Dixie-Narco®

Service Bulletin # 325

MODELS: All Circular Coke - Landscape

SUBJECT: Revision of Coin Insert and Associated Parts

Figure 1

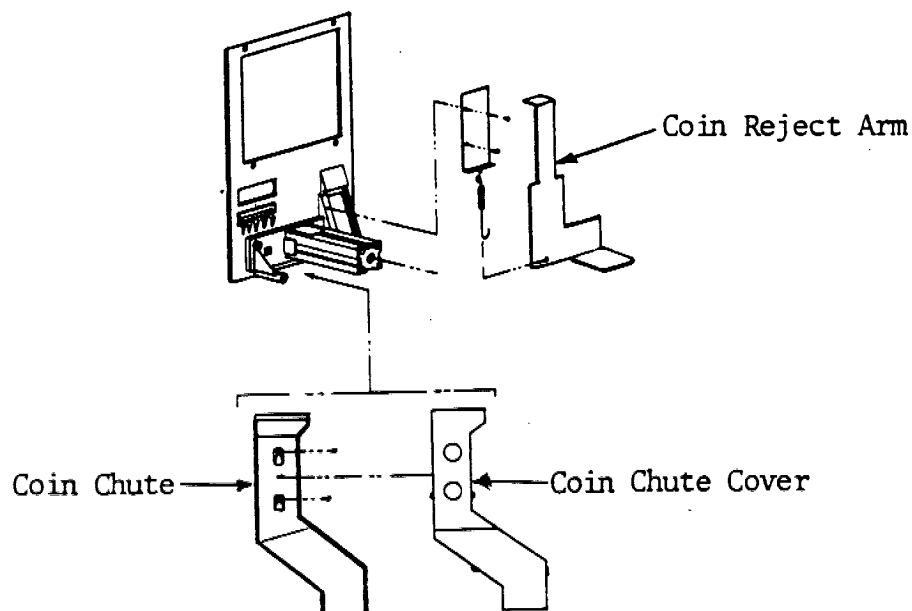
REASON: The Coin Insert was revised for two reasons, (See Figure 1), namely,

- 1a. To change to a 2 piece plastic coin chute i.e., with a removable cover.
- b. The chute is adjustable from left to right i.e., the chute's lower screw hole is slotted.
2. To change the coin reject arm so that it rides in a track thus resulting in a more positive operation.

1. The plastic coin chute is not interchangeable with the metal chute on the prior coin insert.
2. The coin reject arm is not interchangeable with the coin reject arm on the prior coin insert.

IMPORTANT: To obtain the plastic coin chute or the improved coin reject arm for venders with serialization under 0001-2996 the new coin insert with plastic coin chute and the improved coin reject arm would need to be ordered.
